SUNDRY NOTICES AND REPORTS ON WELLS (DO NOT USE THIS FORM FOR PROPOSALS TO DRILL OR TO DEEPEN OR PLUG BACK TO A DIFFERENT RESERVOIR. USE "APPLICATION FOR PERMIT" (FORM C-101) FOR SUCH PROPOSALS.)		WELL API NO. 30-005-20236

NMOCD plans to plug this well in accordance with the attached procedure and any agreed modifications there to.

Cano Petro Of New Mexico
Cato San Andres #068
API: 30-005-20236
Chaves County, New Mexico

Plug And Abandonment Procedure

Proposed Wellbore Diagram

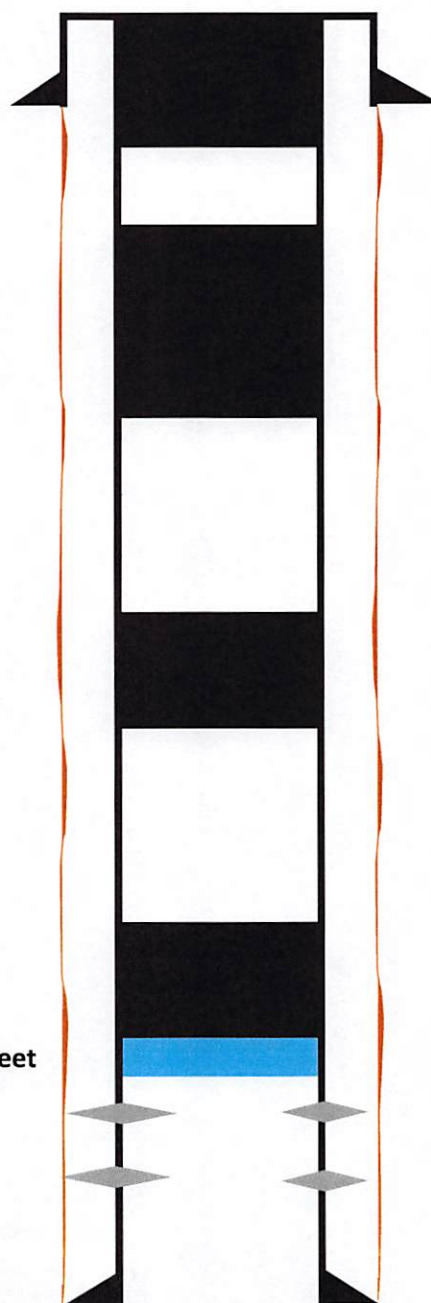
APPROVED WITH CONDITIONS

Perf & Sqz all
plugs above 2300'
